# Special Tool 400 0240 10 and 400 0419 10

## Double clutch cannot be pressed on to the end position

Manufacturer: Audi  
Cupra  
Seat  
Škoda  
VW

Engines: 1,5 TSI, TFSI, eTSI, TGI, TGI-CNG

Figure 1: Press-in sleeve in combination with adapter KL-0500-6031

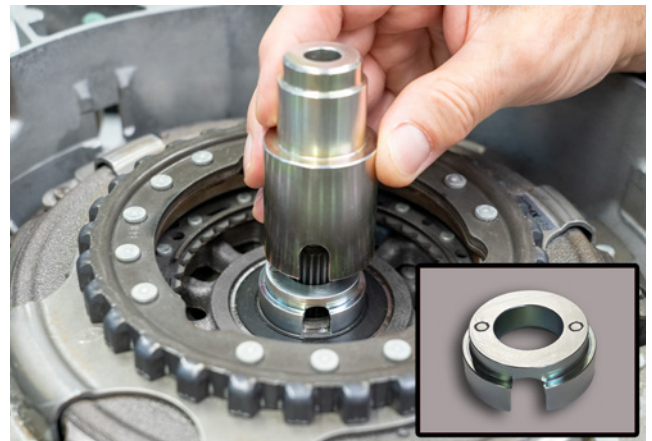
VW Group vehicles with a DQ 200 gearbox and 1.5-liter EVO engines have a gearbox input shaft that is 11 mm longer. Therefore, it is no longer possible to assemble the double clutch using the press-in sleeve from supplementary kit 400 0419 10 that has been used to date and the first version of the double-clutch tool 400 0240 10.

To be able to correctly assemble the double clutch in these cases, the press-in sleeve from the tool kits used to date must be combined with an adapter (Fig. 1) during assembly. The adapter is available under item number KL-0500-6031 in the REPERT bonus shop or directly from the manufacturer, Gedore Automotive GmbH.

Supplementary kit 400 0419 10 is being amended moving forward so that an adapted press-in sleeve is included during production. The new press-in sleeve can be identified by tool number P-0454-1300. Amending the contents of the kit eliminates the need for an adapter.
